Memorandum

To	North Dakota Public Service Commission	Pages	3
Subject	Case Number PU-18-280 Emmons-Logan Wind Energy Center Modifications of Energy Conversion Facility and Site Plan		
From	Emmons-Logan Wind, LLC		
Date	March 17, 2019

**Attachment 17
Delineated Wetlands
Overview Map**

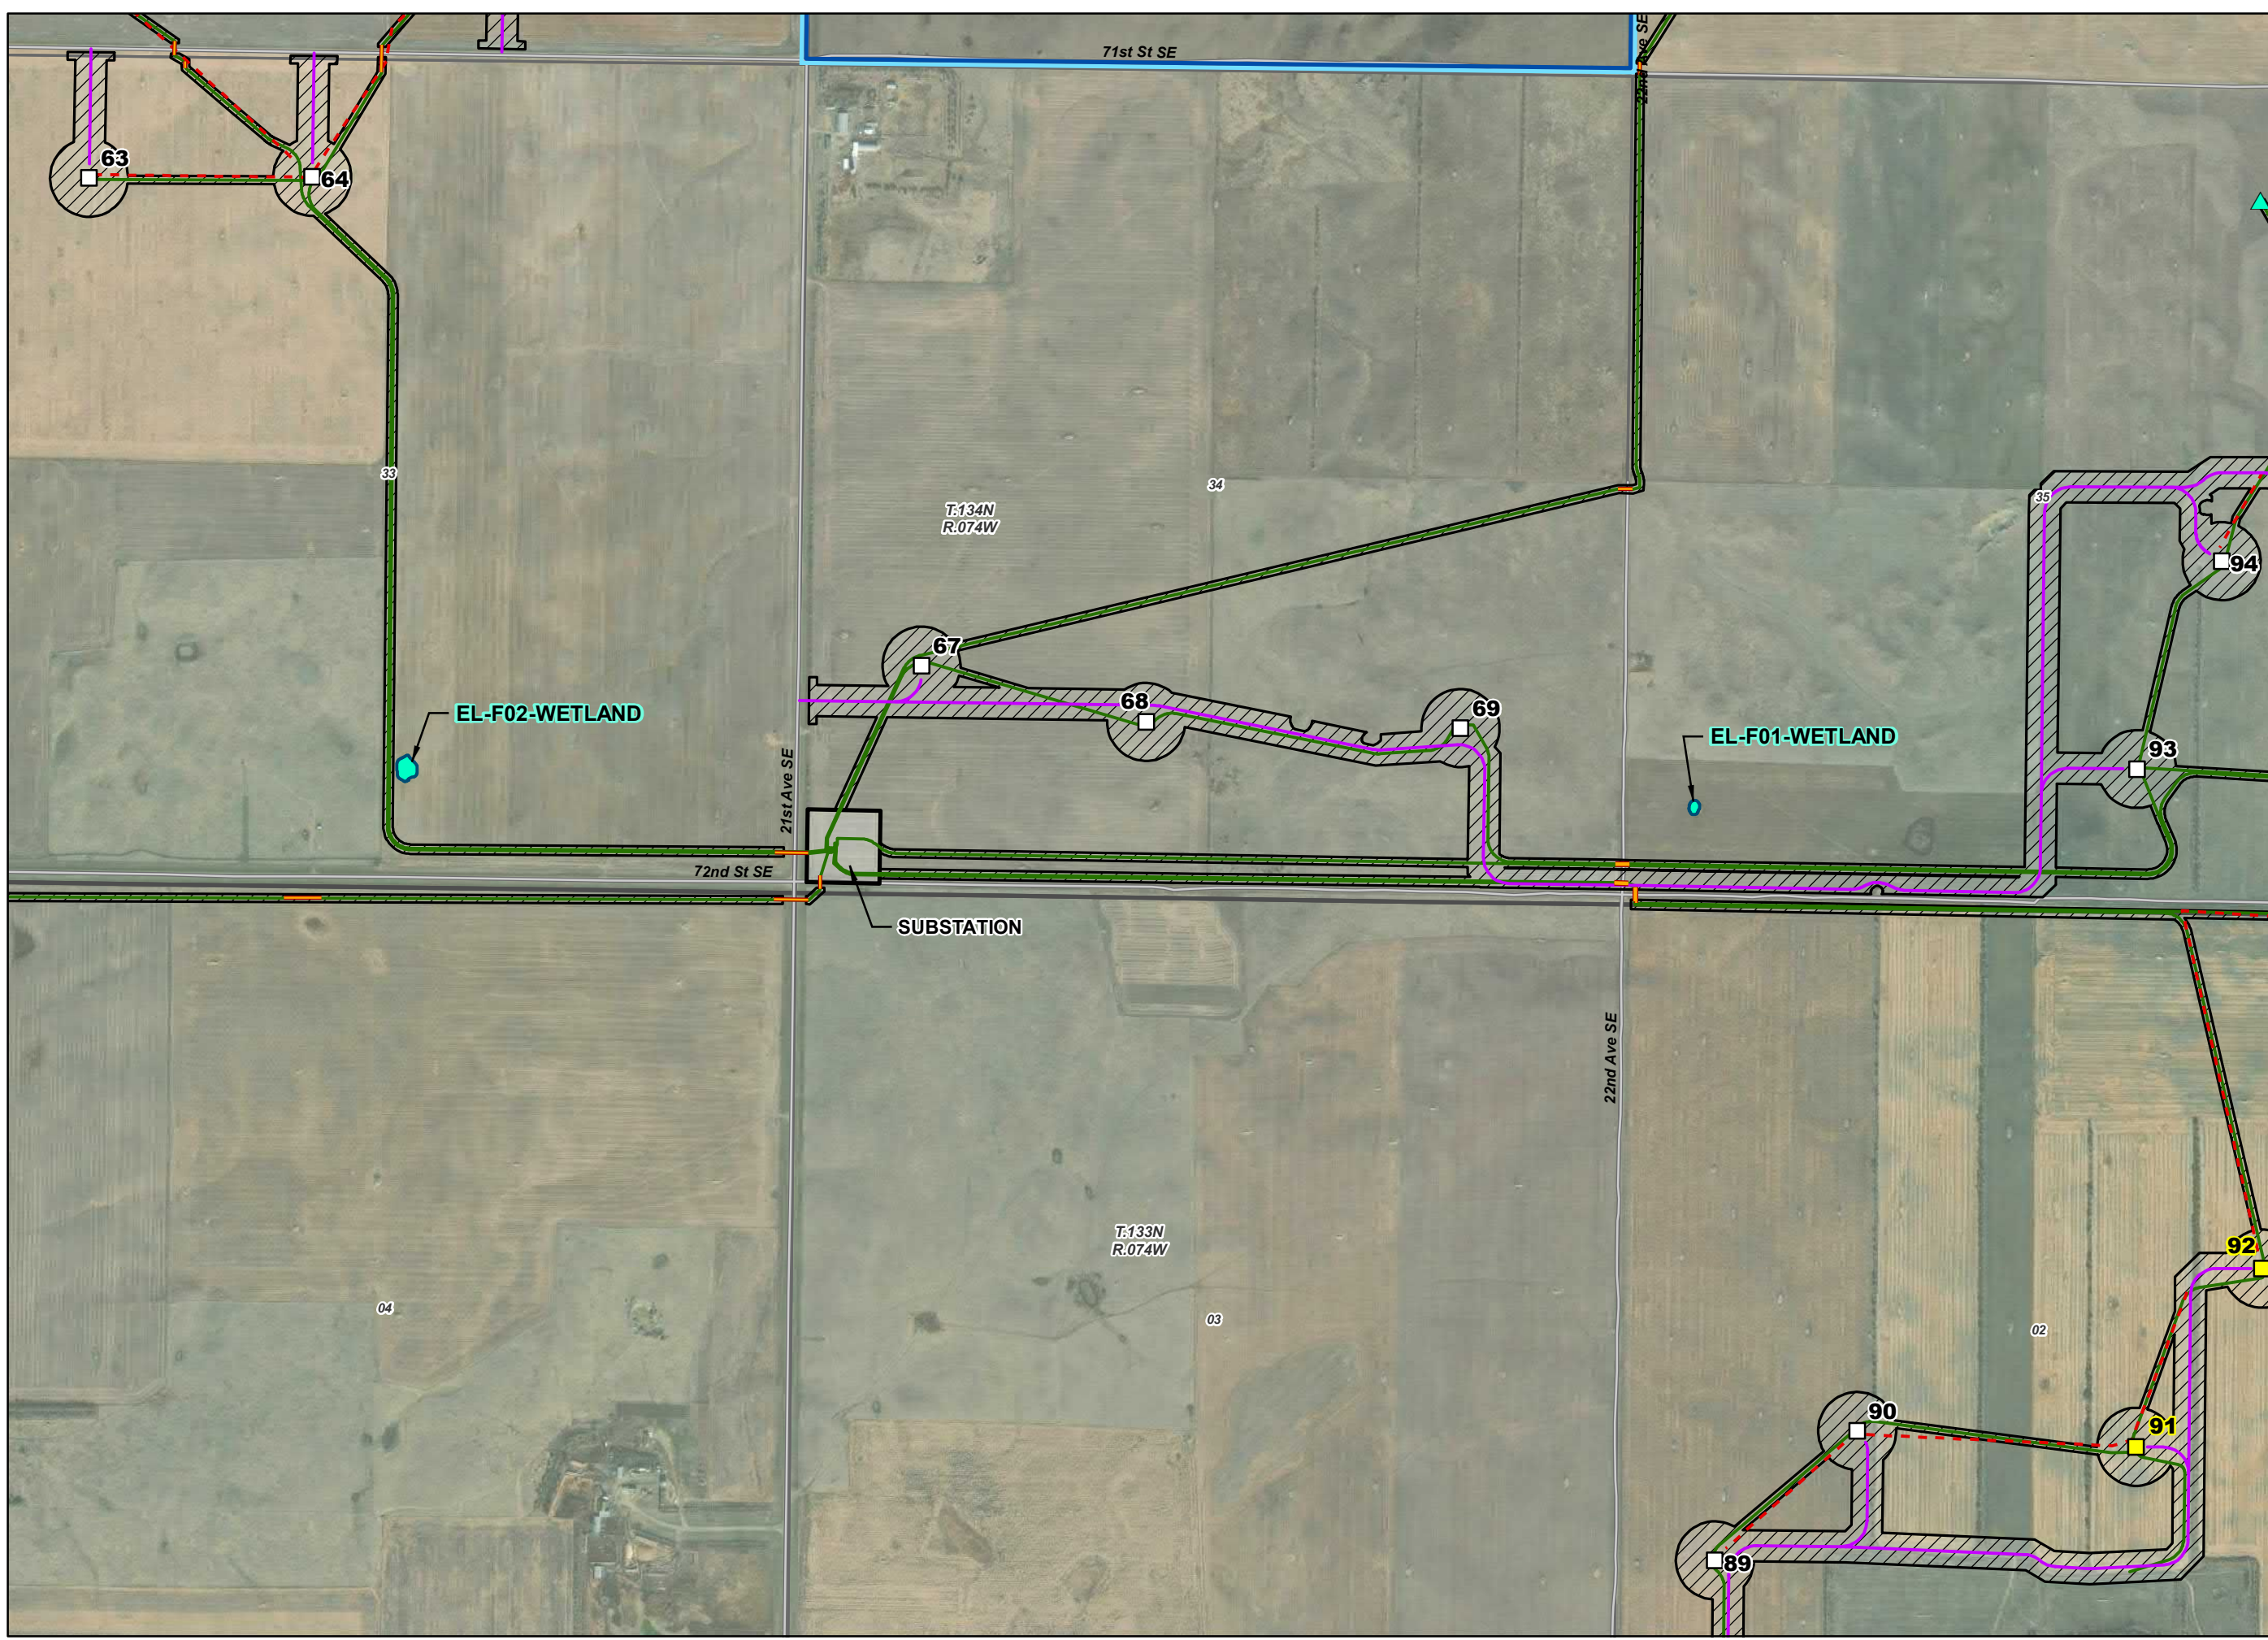
The Site Plan modifications avoid wetland impacts per wetland delineations completed by AECOM. Two additional wetlands (EL-F02-WETLAND and EL-F01-WETLAND) were delineated in the vicinity of the Site Plan modifications, but they are located outside the proposed construction easement and will not be impacted (Attachment 17).
